AMENDMENT OF SOLICITATION/MODIFICATION OF CONTRACT			1. CONTRACT ID CODE	PAGE OF PAGES 1 100
2. AMENDMENT/MODIFICATION NO. 0004	3. EFFECTIVE DATE 22-Mar-2010	4. REQUISITION/PURCHASE REQ. NO.		5. PROJECT NO.(If applicable)

Questions and Answers

Phase 4
201st Corps HQ

01 SITE MASTER PLAN

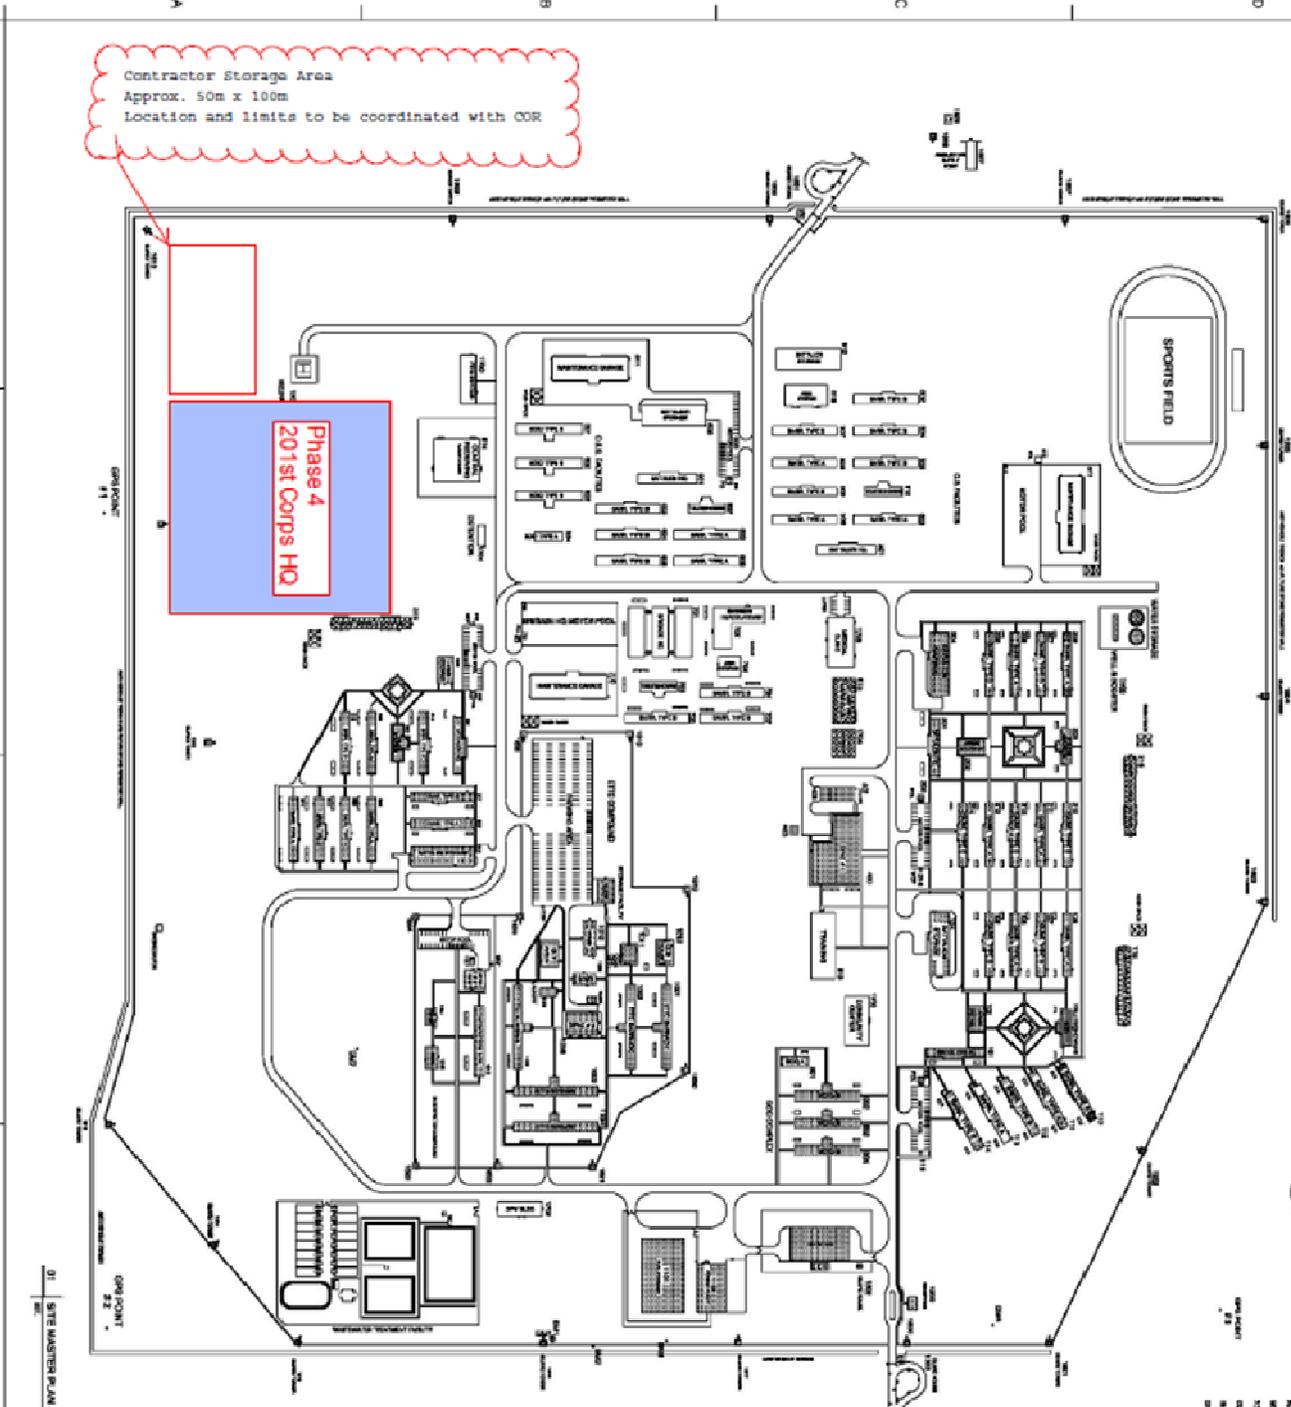
Q4: Can we accommodate a staff in the compound?

Question - Will the contractor be able to establish any life support facilities in space provided for the mobilization area, or will some other suitable area be provided?

A4: Neither the contractor nor his labors will be allowed to reside inside the confines of the Garrison. Referring to the attached figure, a storage lay-down area has identified adjacent to Phase IV.

RESPONSE – The contractor will be confined to the construction storage area.

Contractor Storage Area
Approx. 50m x 100m
Location and limits to be coordinated with COR
